**407590C/D, 407560A/D**  
**SAILOR 1000 XTR GX-R2, SAILOR 600 XTR GX-R2**

**Software Release Note – SAILOR XTR Software 3.12B009**

Document number:	95-181146-I
Date:	June 2024
Author:	OCN

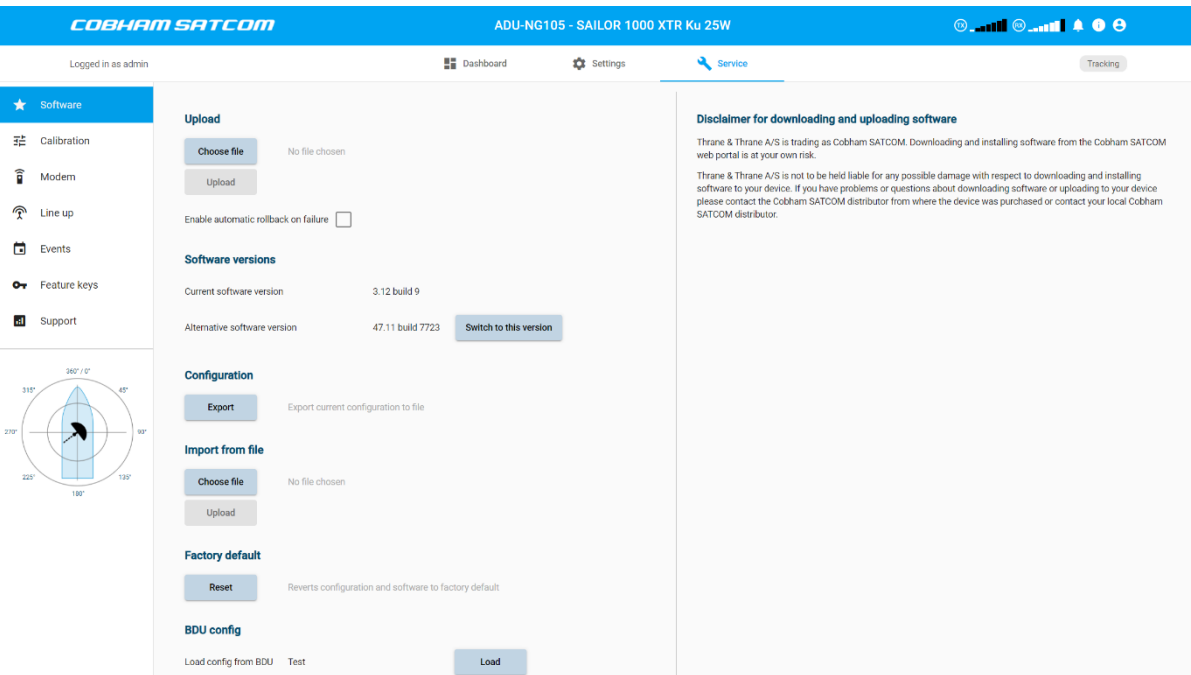
New dashboard with compass rose and active events:

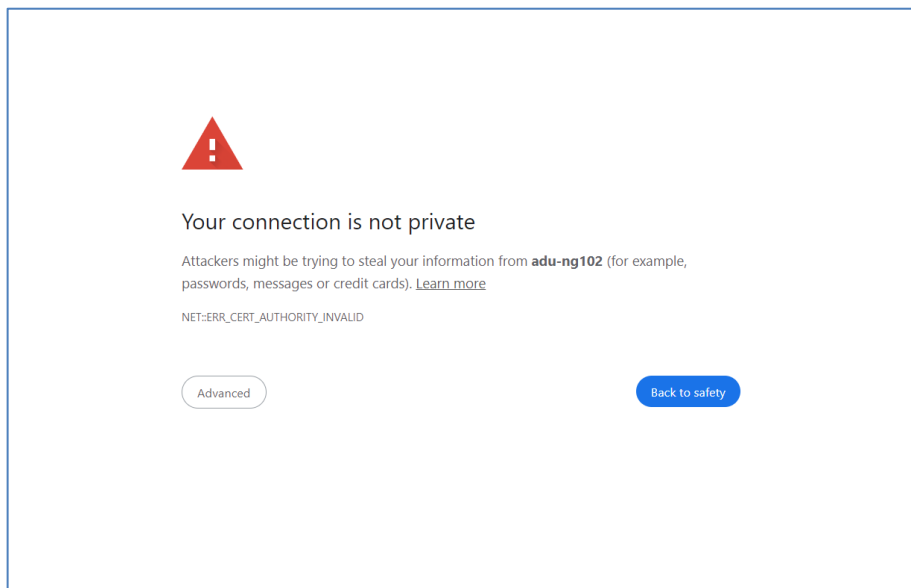
Mandatory redirect from http to https (a small part of the cyber security upgrade, RED and/or E26/E27):

The user needs to click Advanced and select to proceed. Details is browser specific.

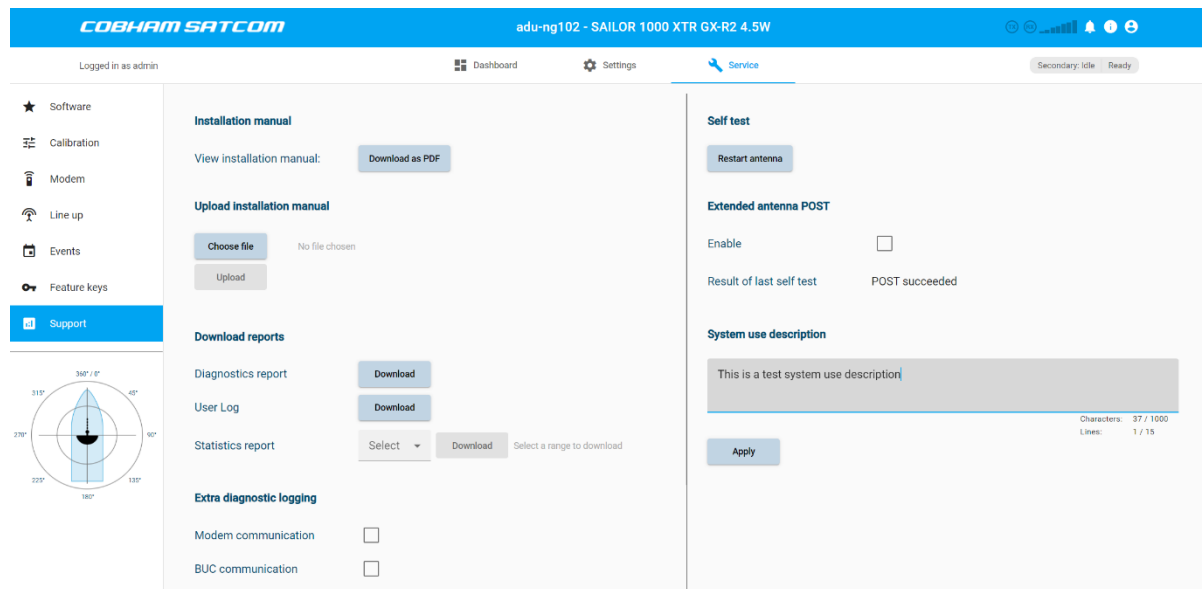
Feature Keys page have been added:

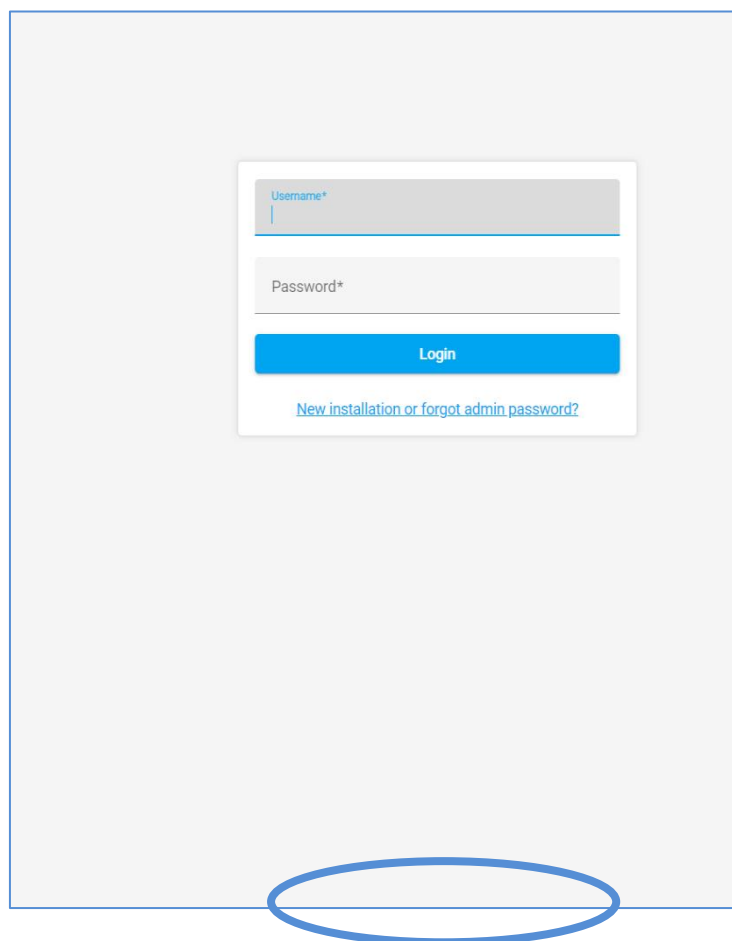
Added system use description (a small part of the cyber security upgrade, RED and/or E26/E27):

This is shown on the login screen:
